**Champlain Hudson Power Express ("CHPE")
Environmental Management & Construction Plan
Notice of Major Change**

Project: Champlain Hudson Power Express

Segment: 9

Notice Number: 123

PERMIT DRAWING NO.	
DRAWING NO.	C-313

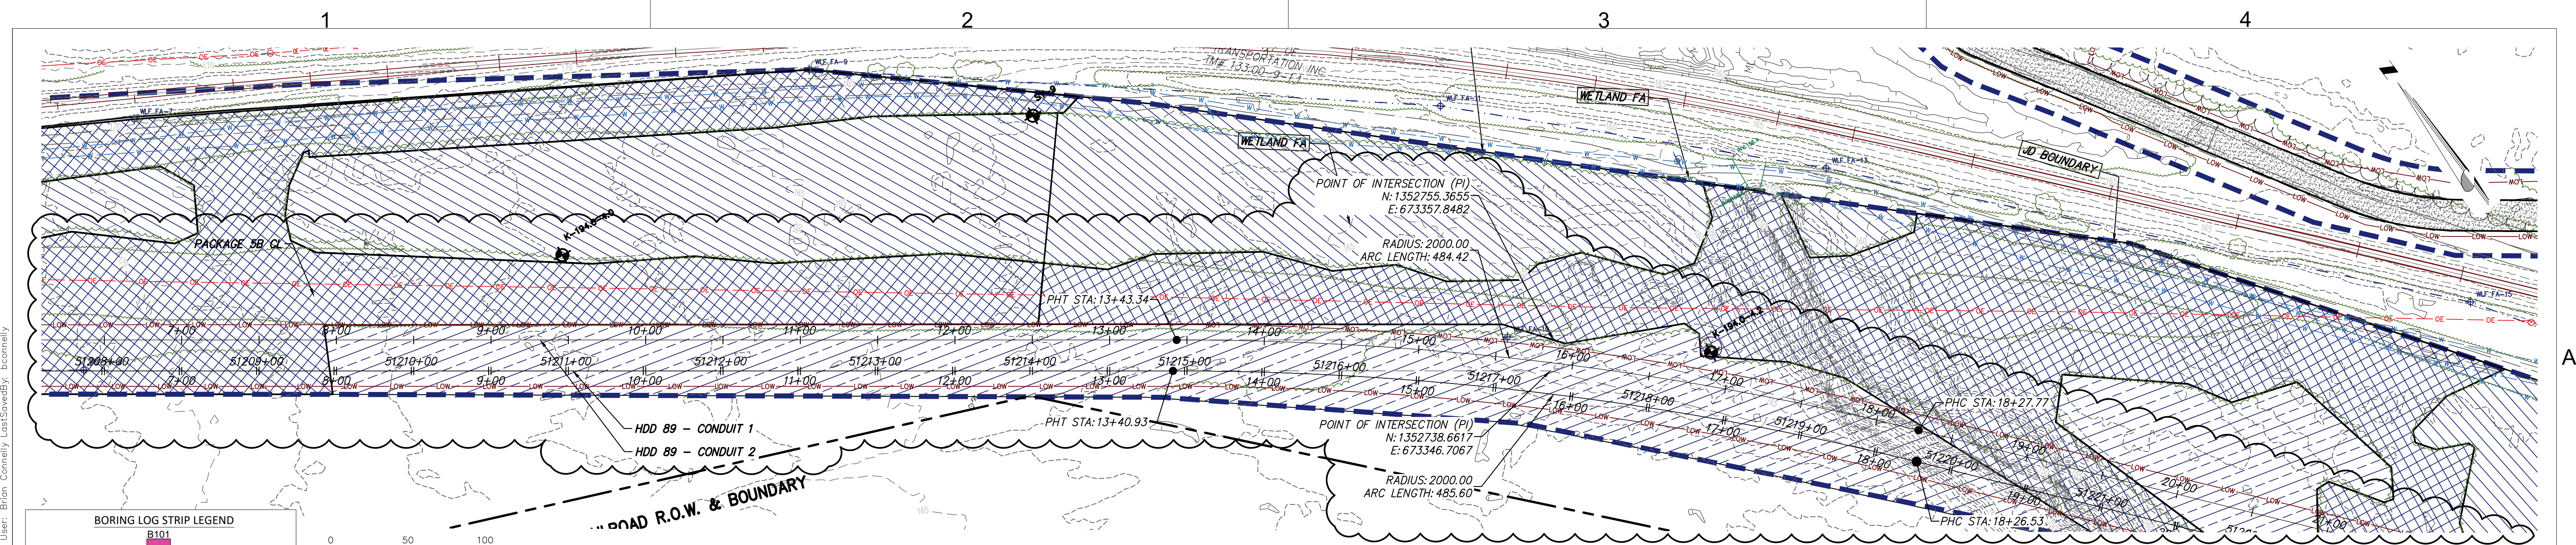
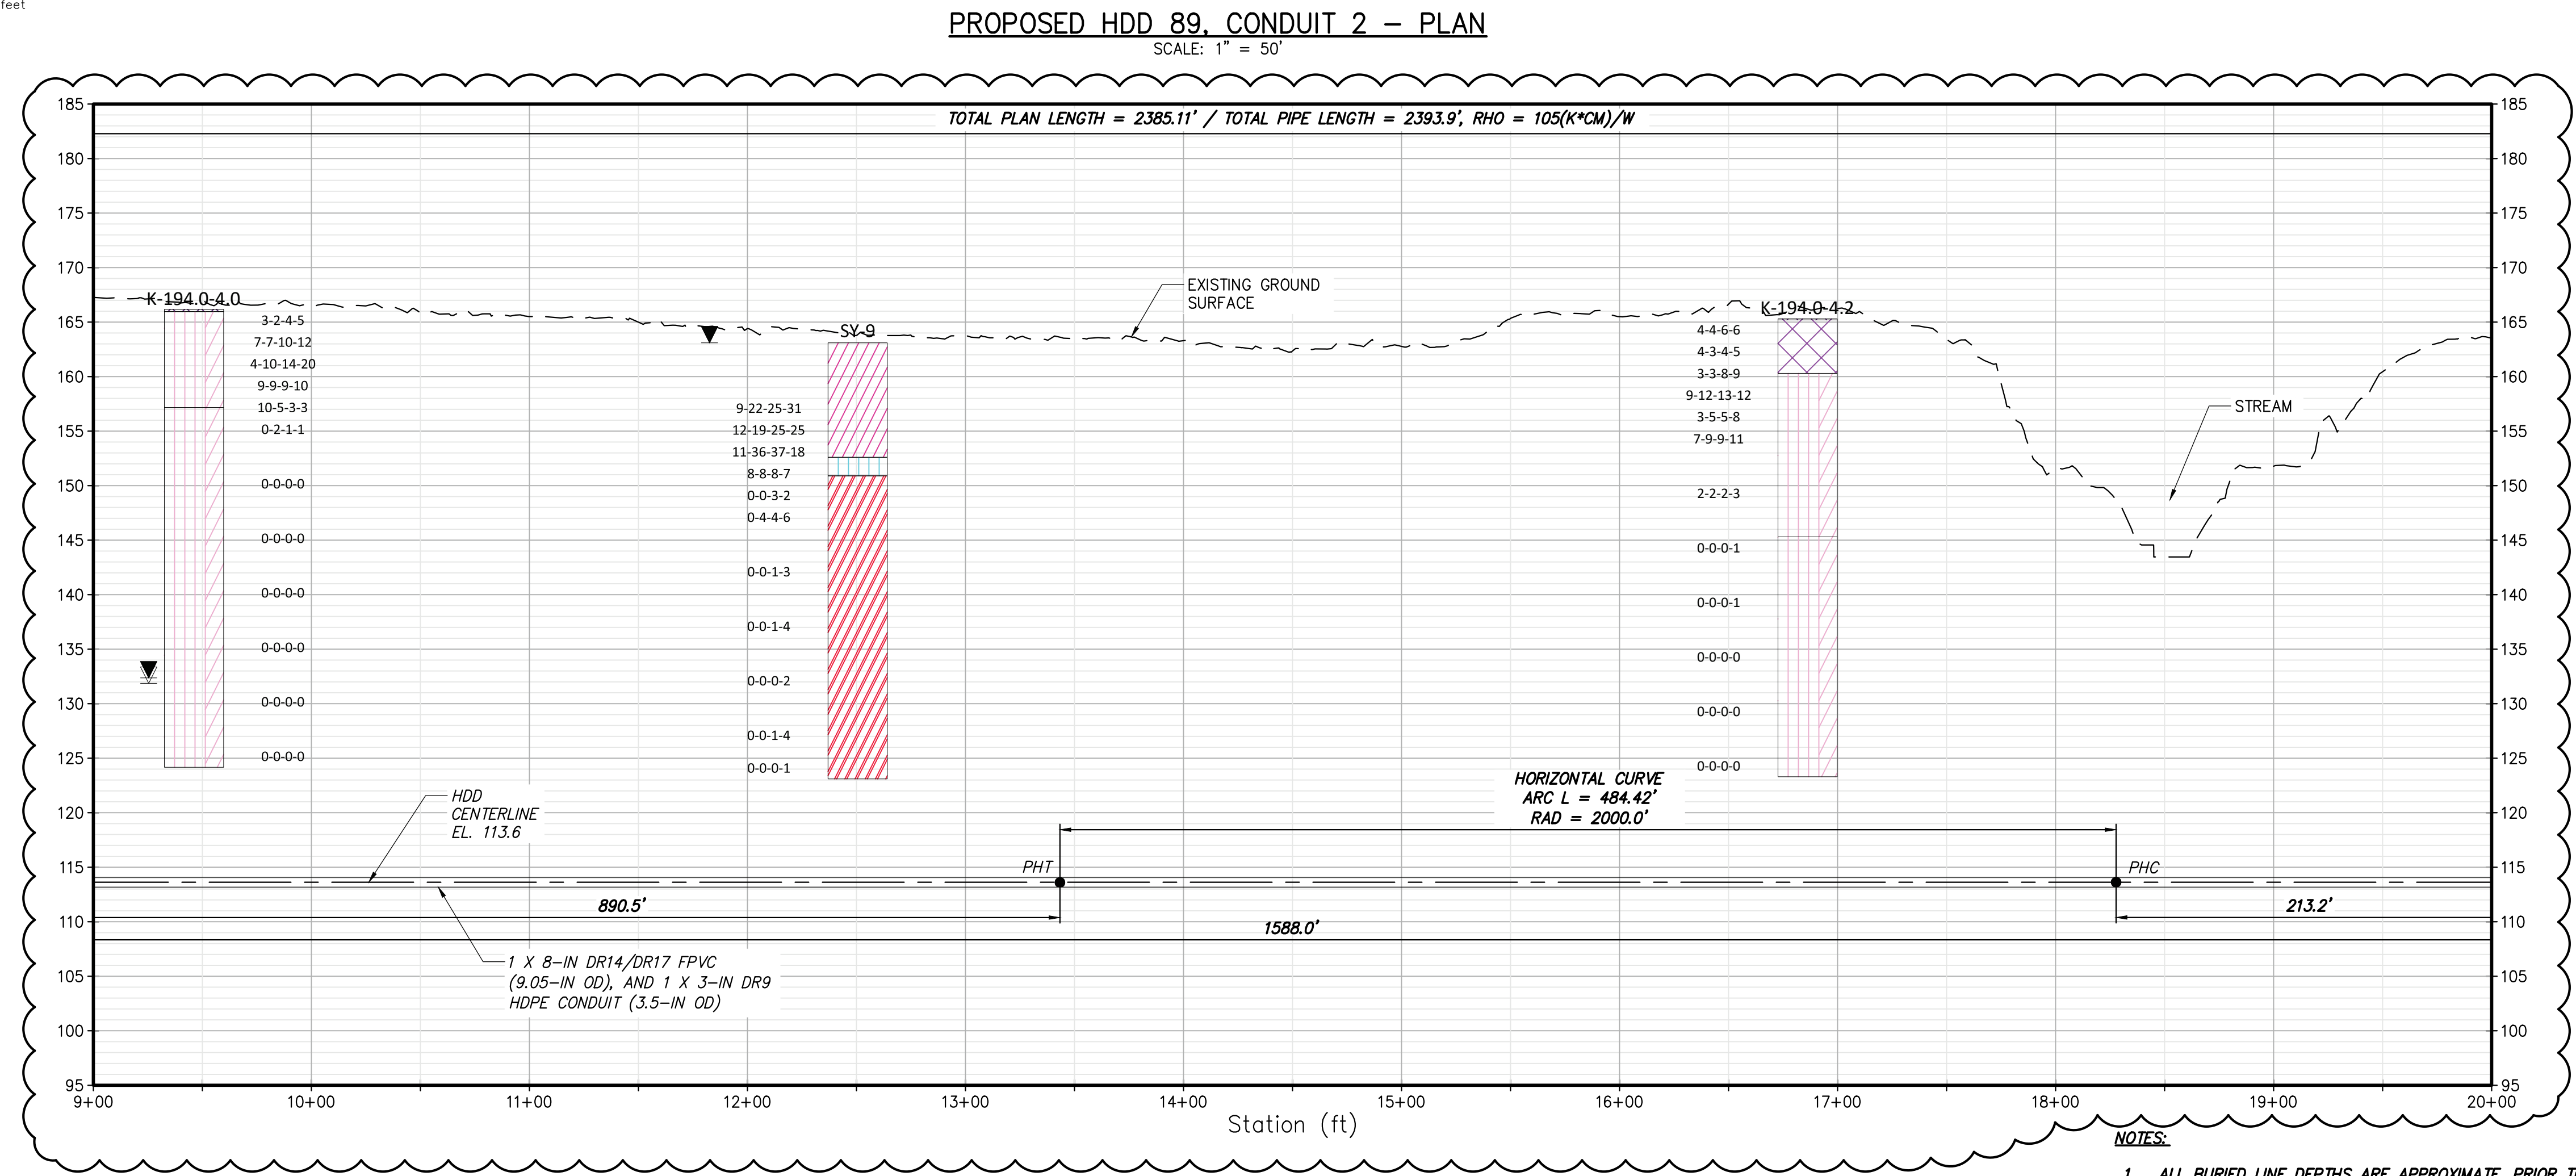
Sheet No.	Rev No.	Revision Description	Summary of Plan Changes
C-114	1	NDC-0005_ALIGNMENT REVISIONS PER NAT. GRID COMMENT	Alignment of HDD adjusted to avoid crossing underneath National Grid overhead electric sub-transmission line from STA 51200+00 to STA 51220+00. Extended HDD 89 workspace in front of pits and adjusted LOW and permanent easement accordingly. Corrected wire pull 191 Direction of cable pull to the preferred reverse direction.
C-115	1	NDC-0005_ALIGNMENT REVISIONS PER NAT. GRID COMMENT	Alignment of HDD adjusted to avoid crossing underneath National Grid overhead electric sub-transmission line from STA 51200+00 to STA 51220+00. Extended HDD 89 workspace in front of pits and adjusted LOW accordingly.
C-116	1	NDC-0005_ALIGNMENT REVISIONS PER NAT. GRID COMMENT	Alignment of HDD adjusted to avoid crossing underneath National Grid overhead electric sub-transmission line from STA 51200+00 to STA 51220+00. Extended HDD 89 workspace in front of pits and adjusted LOW accordingly. Corrected wire pull 193 Direction of cable pull to the preferred reverse direction.

No.	DATE	SUBMITTAL / REVISION DESCRIPTION	DB	APP
1	04/19/2024	NDC-0005_ALIGNMENT REVISIONS PER NAT. GRID COMMENT	NS	BD
0	06/09/2023	ISSUED FOR CONSTRUCTION SUBMISSION	NS	BD

DRAWING NO. C-407

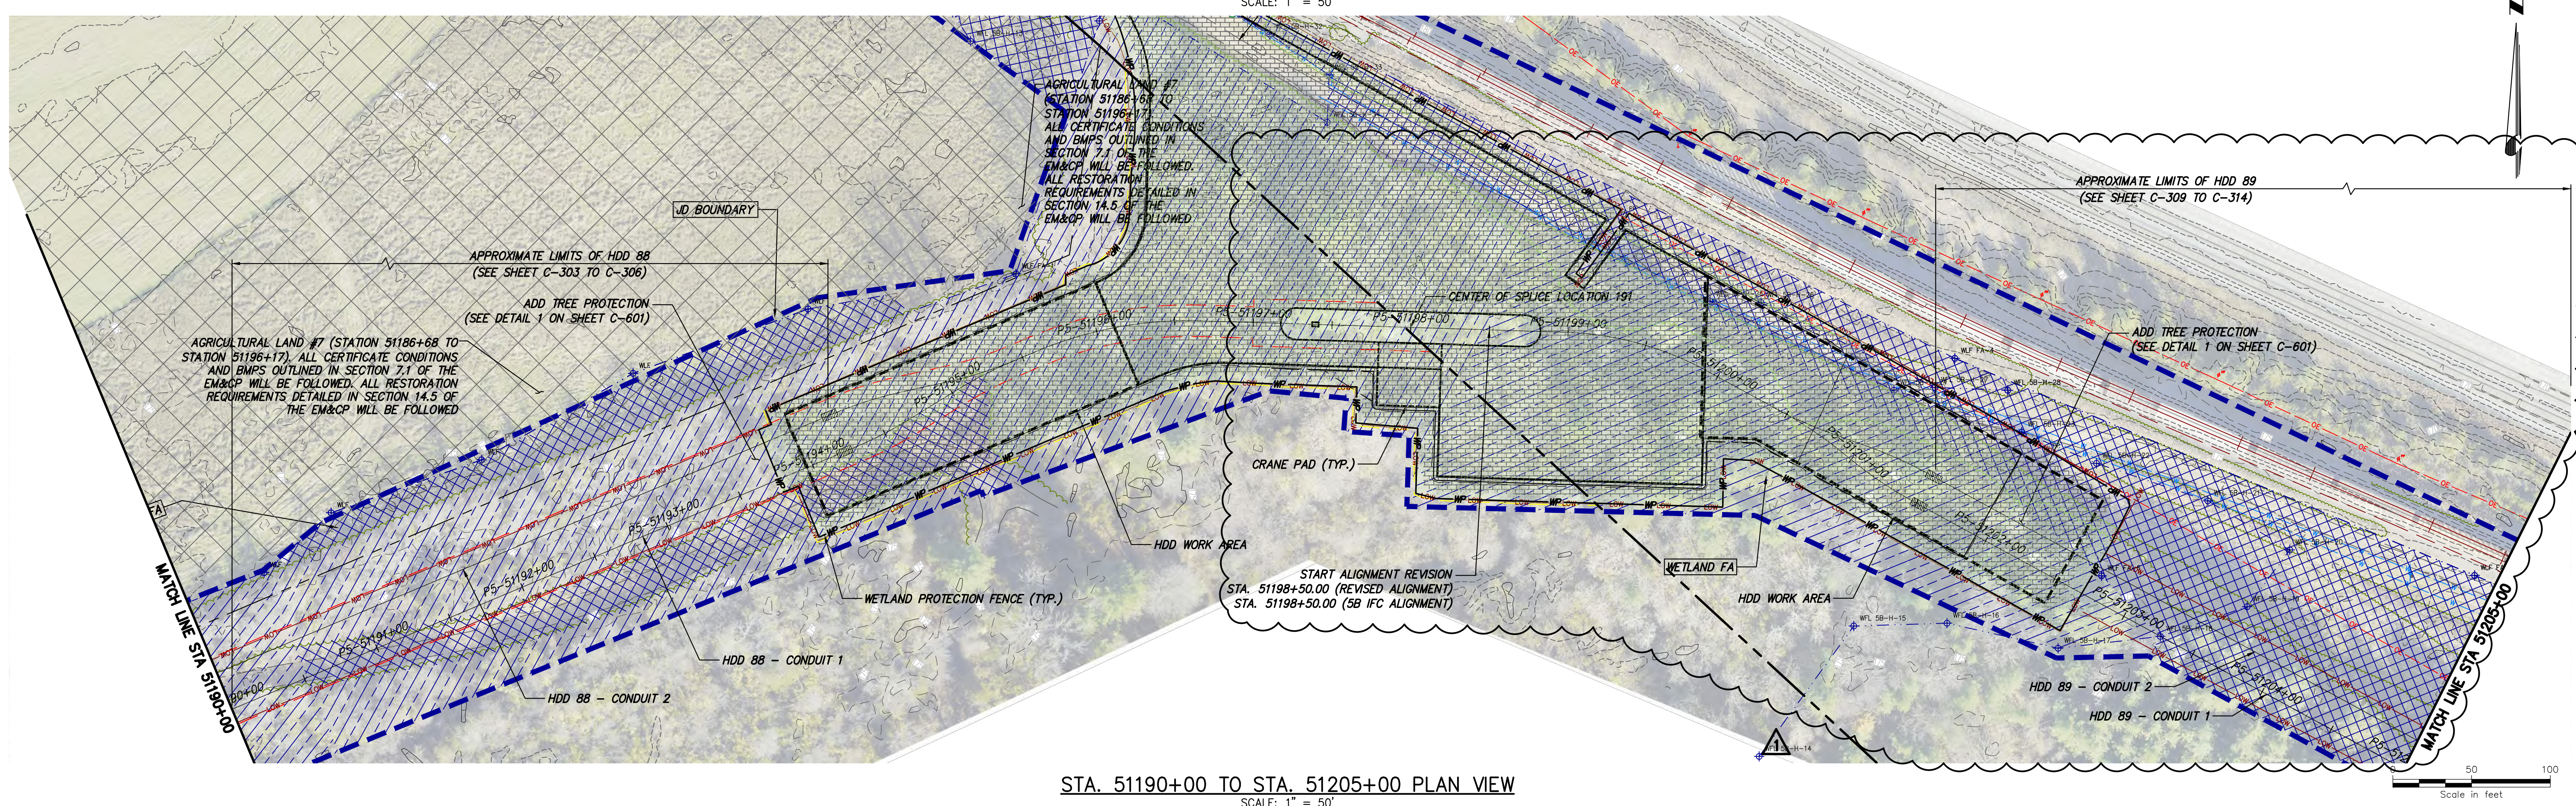
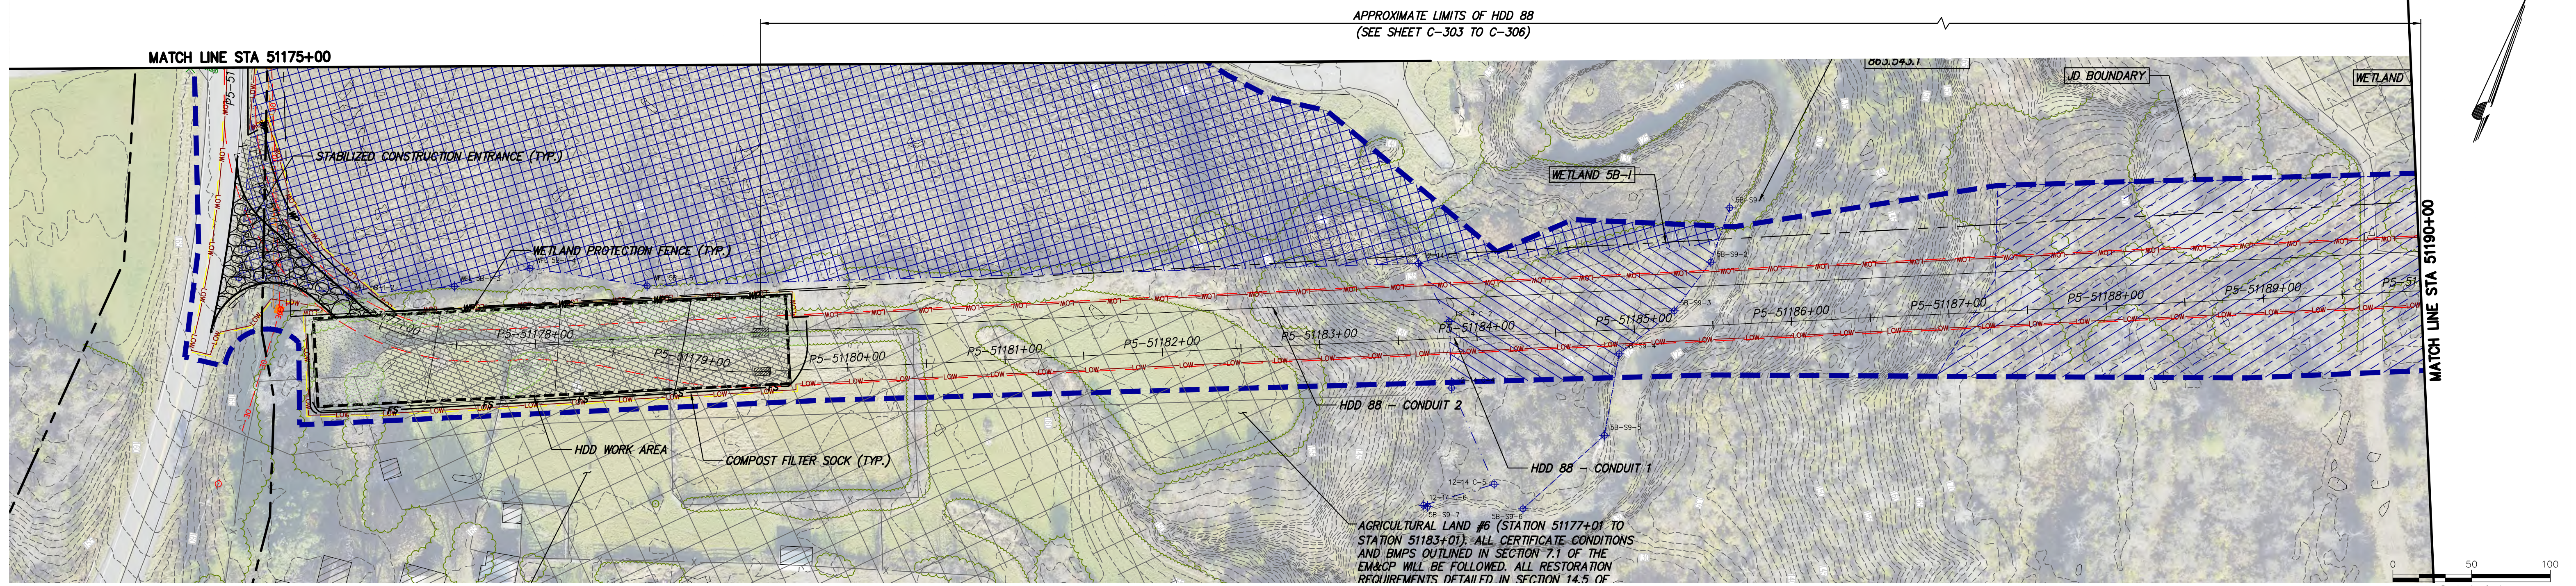
C-407	1	NDC-0005_ALIGNMENT REVISIONS PER NAT. GRID COMMENT	Replot of sheet to capture alignment and LOW changes. Updated tree clearing limits and perimeter ESC measures accordingly.
C-408	1	NDC-0005_ALIGNMENT REVISIONS PER NAT. GRID COMMENT	Replot of sheet to capture alignment and LOW changes. Updated tree clearing limits and perimeter ESC measures accordingly.

No.	DATE	SUBMITTAL / REVISION DESCRIPTION	DB	APP
1	03/26/2024	NDC-0005: ALIGNMENT REVISIONS PER NAT. GRID COMMENT	BL	BD
0	06/09/2023	ISSUED FOR CONSTRUCTION SUBMISSION	MK/TH	NH
